SERVICE 		6
		X 91.116-26

MODELS 40/45, 51/55

STARTER

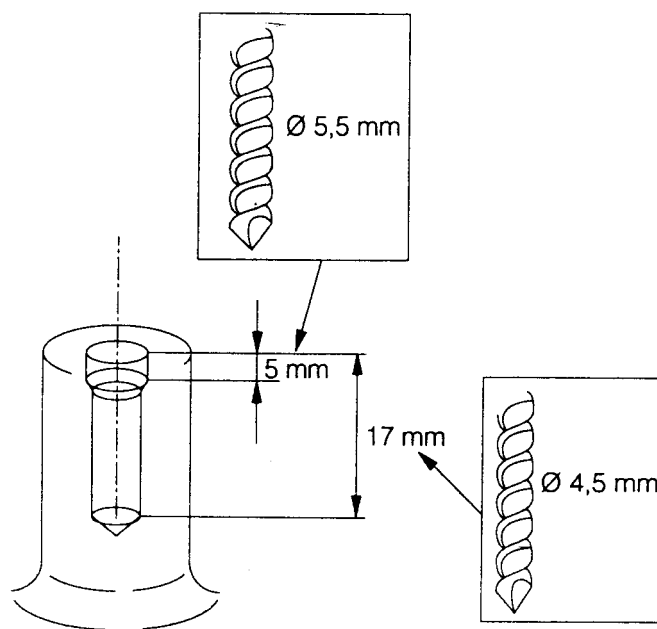
We have increased the inner diameter on the pulley centre post due to plastic moulding reasons. This requires a bigger screw. The change is already introduced on the models 51/55 and will be introduced on the models 40/45.

The old screw, 503 21 32-16 will be replaced by the new one, 503 21 06-16. This means that the old pulley hole for the starter must be modified in order to fit the new screw. See the illustration below.

Both starters keep their earlier Ref. Nos. but get a new manufacturing code.
40/45 = T and 51 /55 = Q.
